FORTUNE SYSTEMS CORP.
SERVICE NOTICE INDEX

FORTUNE SYSTEMS CORP

SERVICE NOTICE

NUMBER 0002

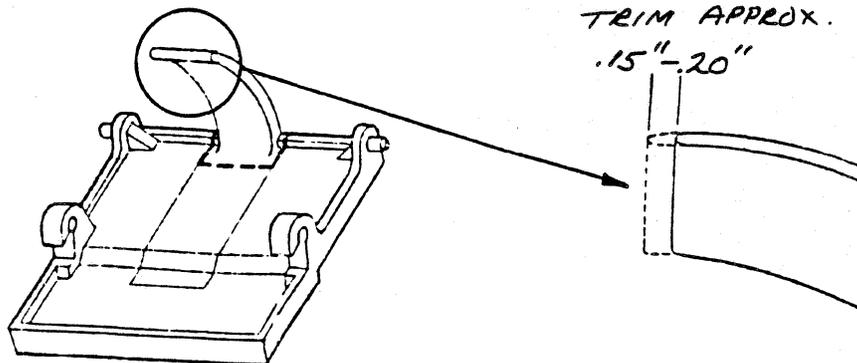
PROBLEM: FLOPPY DISK DOOR SENSE SWITCH ON SHGUART DRIVES MAY NOT BE OPERATING PROPERLY DUE TO THE TONGUE ON THE DOOR.

SOLUTION: CHECK THAT THE TONGUE ON THE BACK OF THE FLOPPY DISK DOOR IS ALLOWING THE DOOR SWITCH TO OPEN AND CLOSE PROPERLY. THIS IS BEST DONE BY REMOVING THE TOP COVER AND OBSERVING THE OPERATION OF THE DOOR AND SWITCH BY LOOKING DOWN AT THE DOOR FROM THE TOP. IF THE SWITCH IS NOT MAKING PROPERLY TRIM WITH DYKES OR FILE ABOUT .20" FROM THE END OF THE FLOPPY DISK DOOR TONGUE. REFER TO DRAWING BELOW.

NUMBER 0003

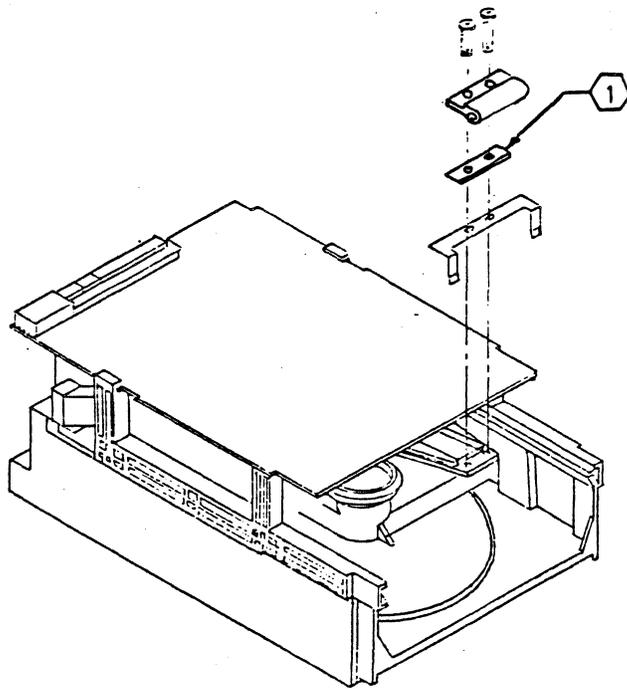
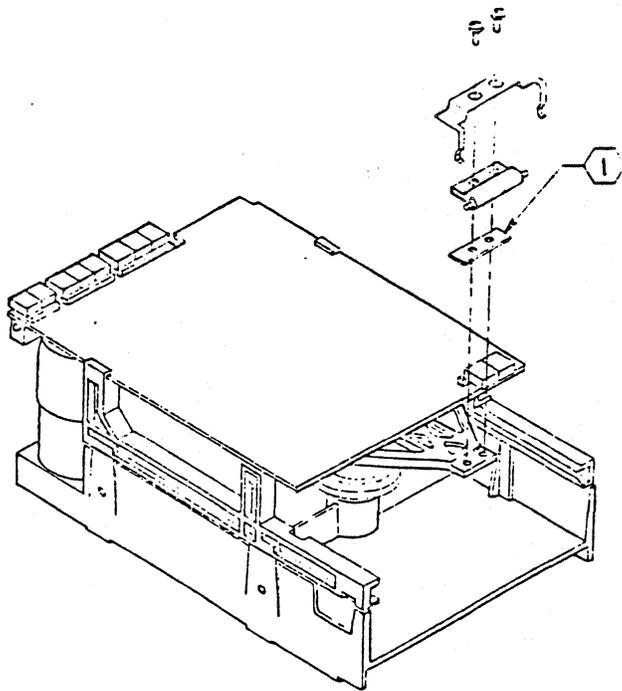
PROBLEM: Possible error in assembly of Spacer on floppy disk door.

SOLUTION: Insure Spacer is installed per the attached drawing on each of the floppy drive types.

FIGURE 1.0

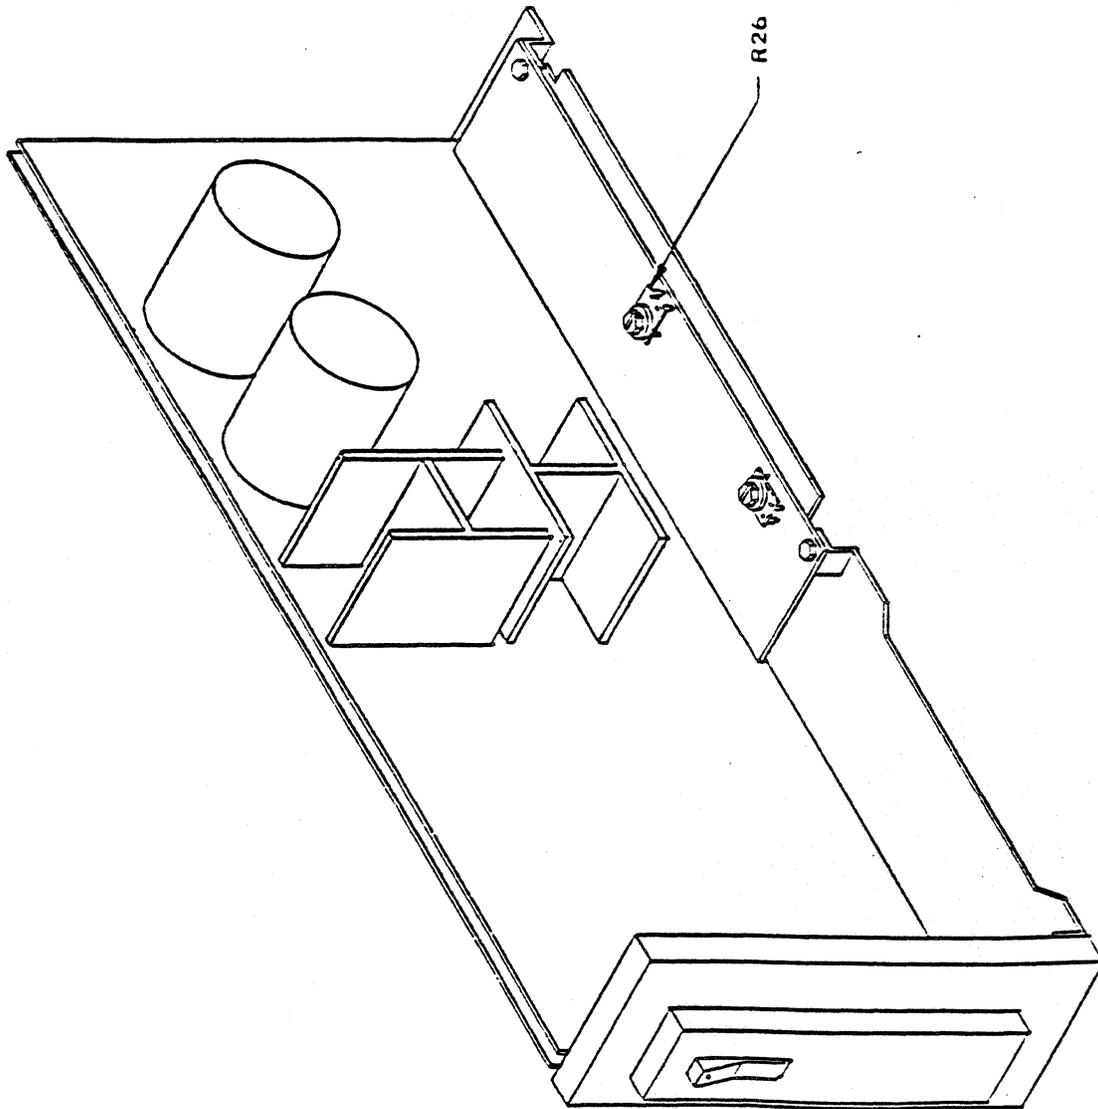
Check the +12 volt output, it should be less than 12.60 volts. If it is above, adjust potentiometer R26 (see Figure 1.0) until voltage is 12.60 volts.

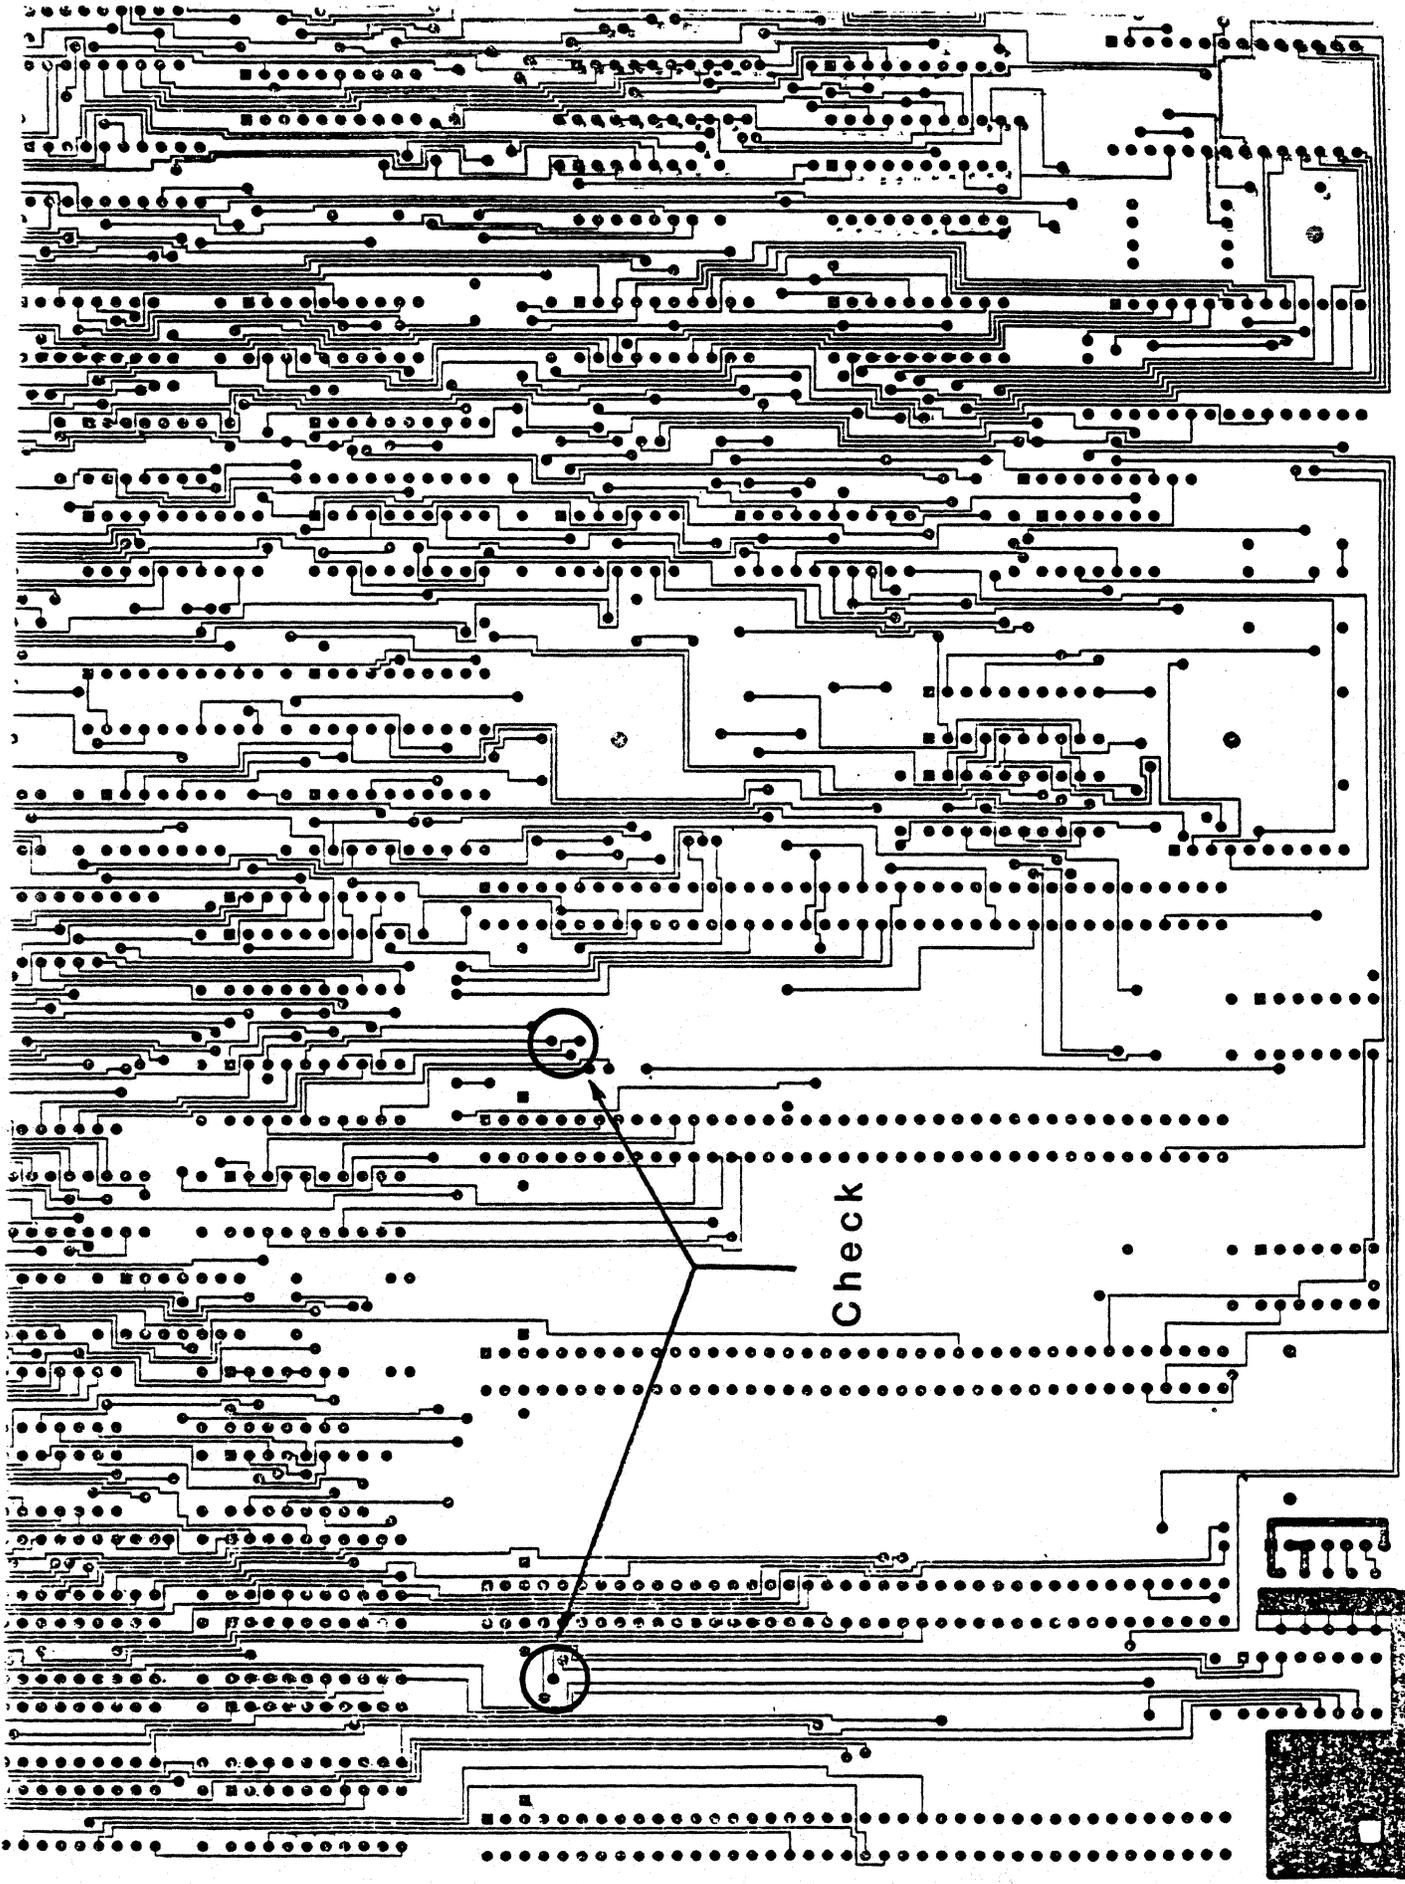
SOLUTION: If a system problem is isolated to a motherboard check the six solder pads, shown in the two circles on the following page, for solder shorts from these pads to adjacent traces. Remove all excess solder with an exacto knife being very careful not to damage the motherboard.

Recheck the motherboard in the system if excess solder was removed.

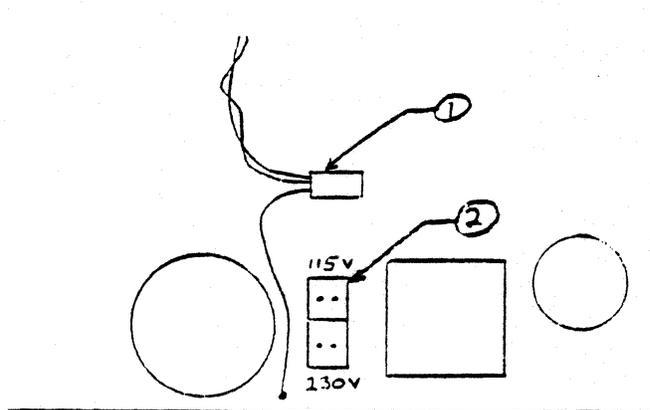
PROBLEM: Fortune Systems is now shipping a power supply manufactured by Western Electric under the part number 1001851-01.

4. Select 110 or 230 VAC operation by moving the jumper plug as indicated on the drawing below. 110 VAC in the upper position, 230 VAC in the lower position.

FIGURE 4
TOP COVER INSULATOR ASSY

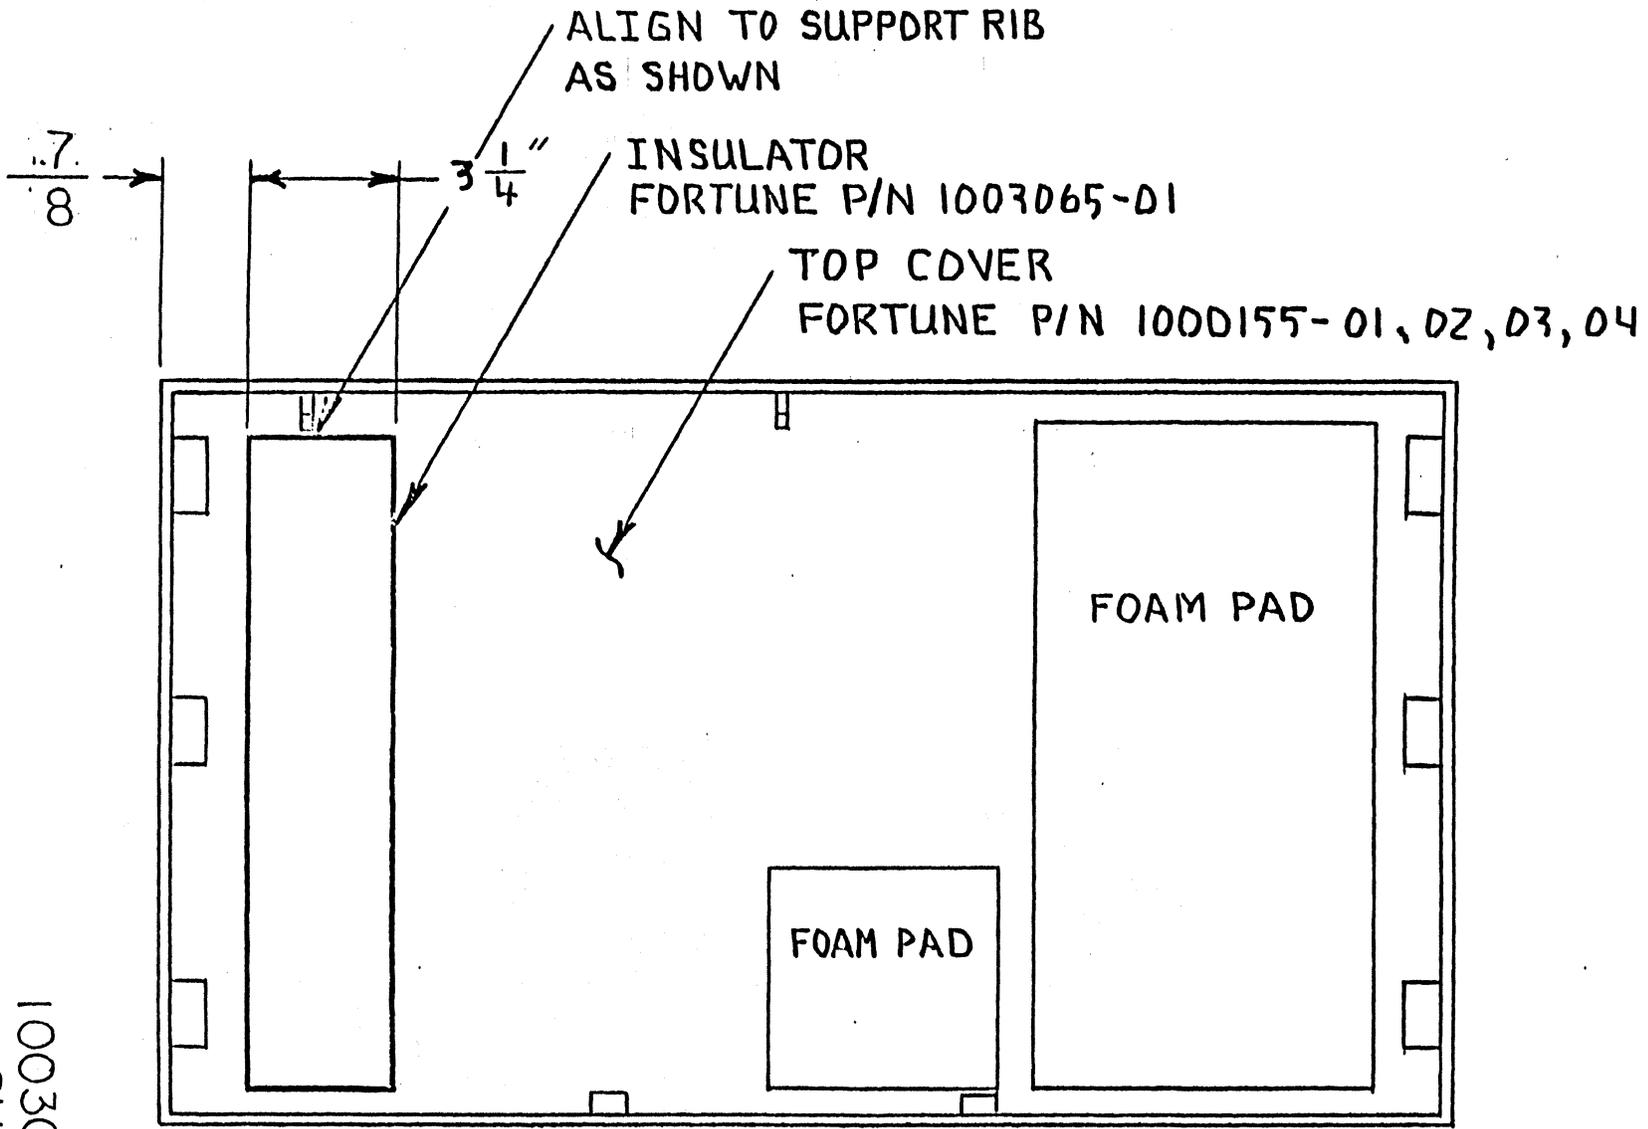
WIRE MUST REMAIN BELOW TAB ②
SO THAT WIRES DO NOT BECOME
PINCHED BY COVER .

FIGURE 1.0

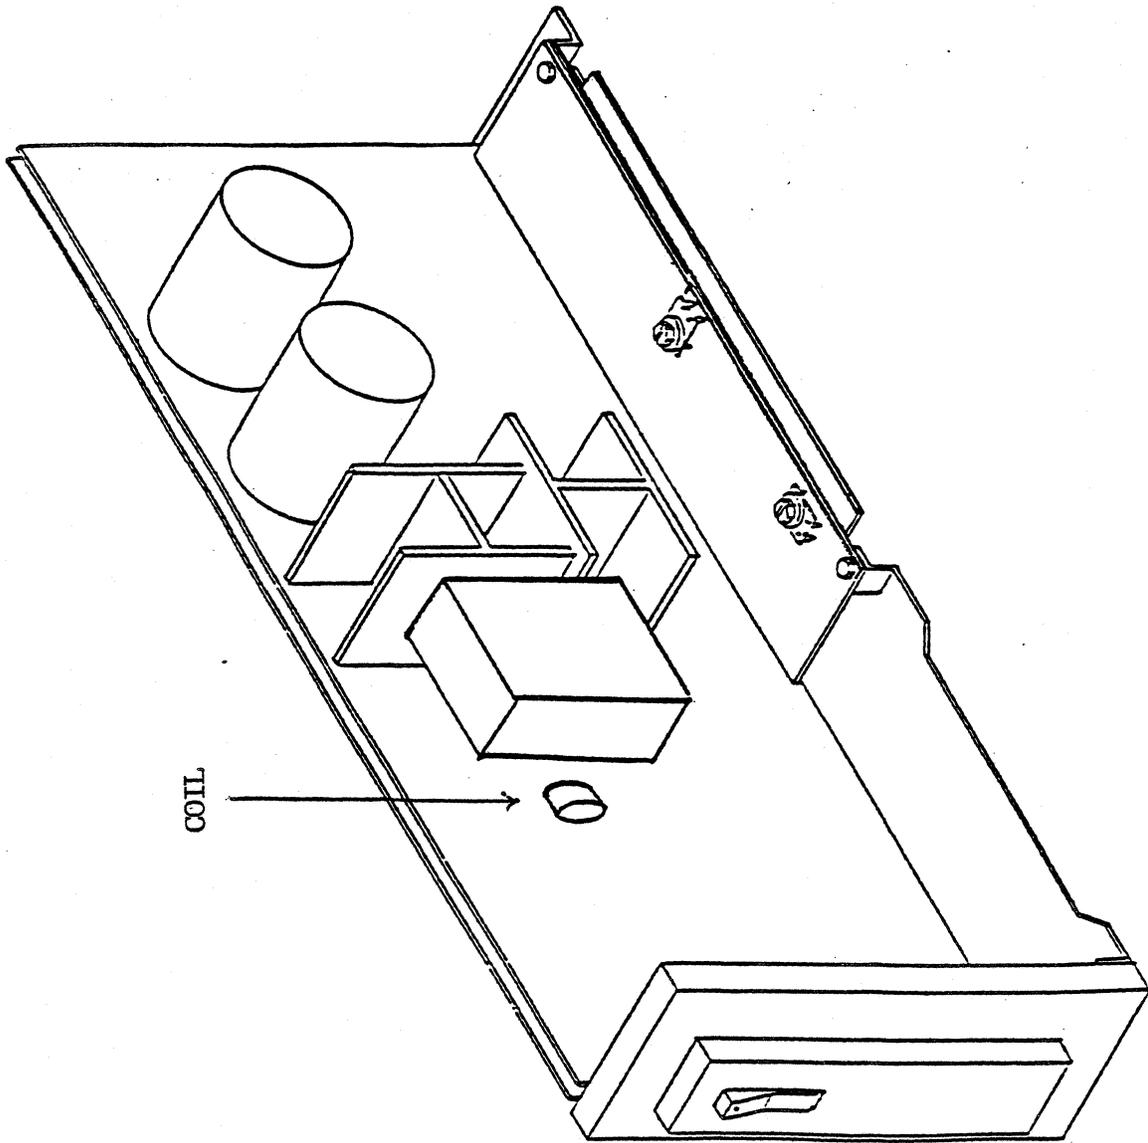
The first was a 22 amp supply (1000050-01 or 02). The Zenith part number (OE-A-00012 is located on the back of the supply. It can be further identified by the absence of a small coil on the power supply electronics board. See figure 1.0 for details.

The second was a 28 amp supply (1000050-03 or 04) also manufactured for Fortune by Zenith. The Zenith part number (OE-A-00012-01) is located on the back of the supply. It can be further identified by the presence of a small coil on the power supply electronics board. See figure 1.0 for detail.

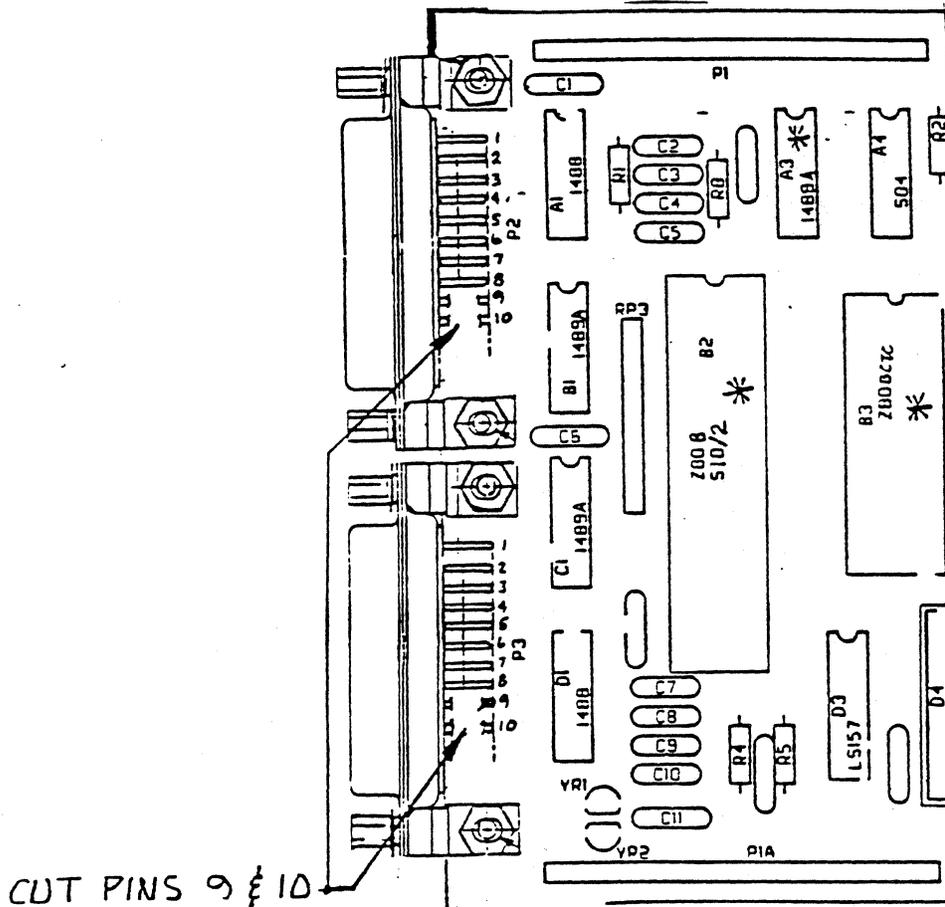
PROBLEM: The ComB is a DTE device and should not have + and - 12 volts on Pins 9 and 10 of the RS232 connectors. This could possibly damage modems when used with a non-Fortune cable.

SOLUTION: If you are going to connect a ComB to a modem with a non-Fortune cable, do the following rework to the ComB.

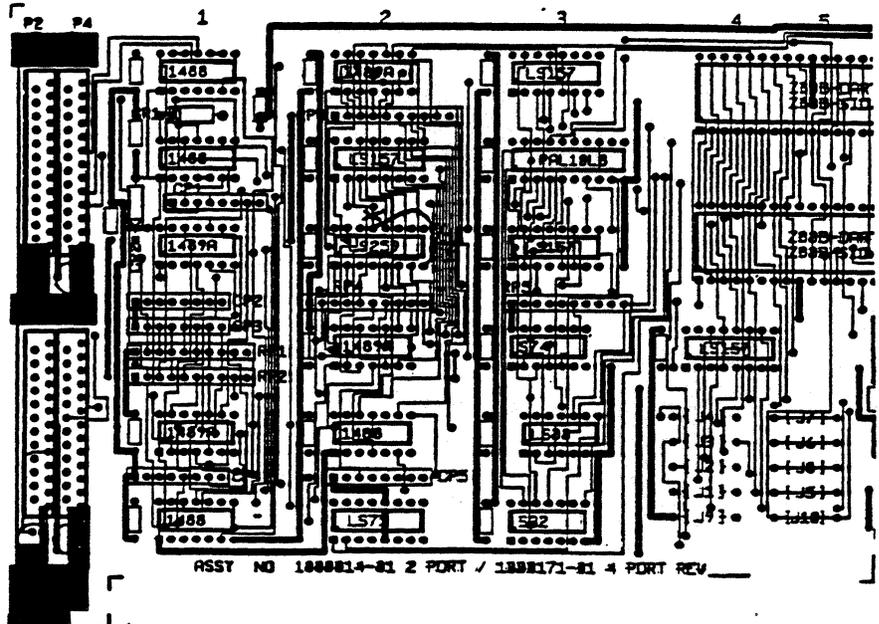
SOLUTION: A simple fix to this problem is to disable the circuitry involved with internal loop-back. Do the following rework to the ComA's. Cut trace going to IC 2C Pin 13. Solder a wire between IC 2C Pin 13 and IC 2C Pin 8. See details below. Revision 11 and above ComA's will not have to be modified.

CUT TRACE EXACTLY WHERE SHOWN
2C13 to 5C40
ADD WIRE: 30 AWG KYNAR
2C13 to 2C8

Figure 5

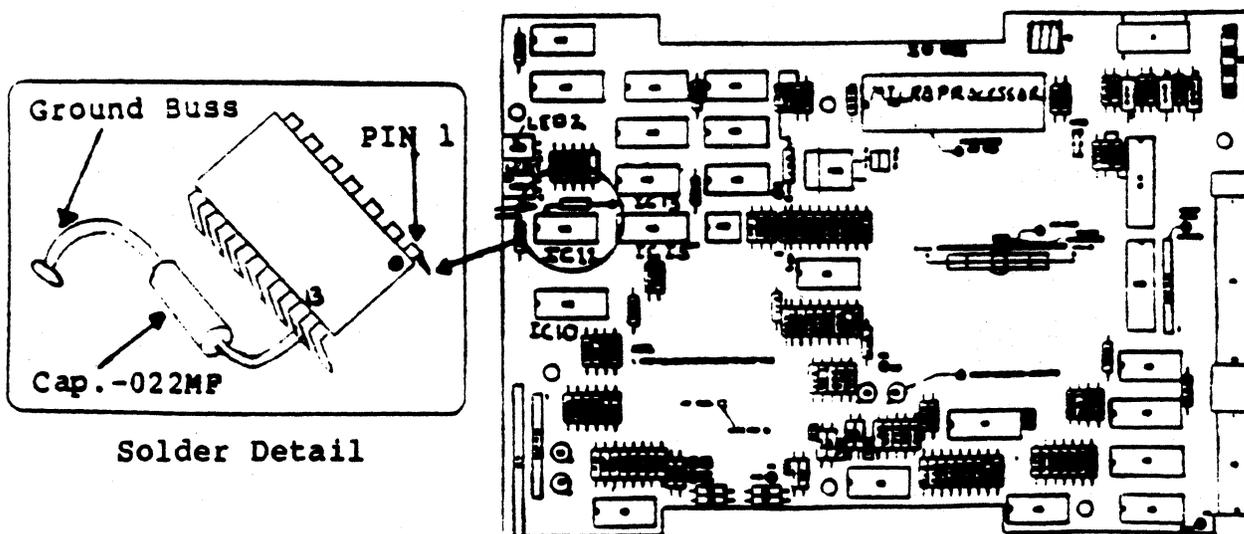
Check the microprocessor IC22 (40 pin chip on component side of logic board) to see if proper chip is installed. If the drive has a narrow band stepper motor (see figure 3) the correct numbers should be 6109-2. If the drive has a wide band stepper motor (see figure 4) the correct numbers should be 6052-13B. If the microprocessor is the wrong revision, call Customer Support (415) 594-2949 for a replacement, be sure to also ask for a capacitor (part# 1000376-08). After replacing the microprocessor, install the capacitor.

With Disk Drive PCB component side up solder one end of capacitor to IC11 PIN 13 and the other end to Ground Buss (see figure 5, Solder Detail). Ground Buss is located between IC13 and IC15.

NOTE: DO NOT let leads of capacitor touch leads on IC11.
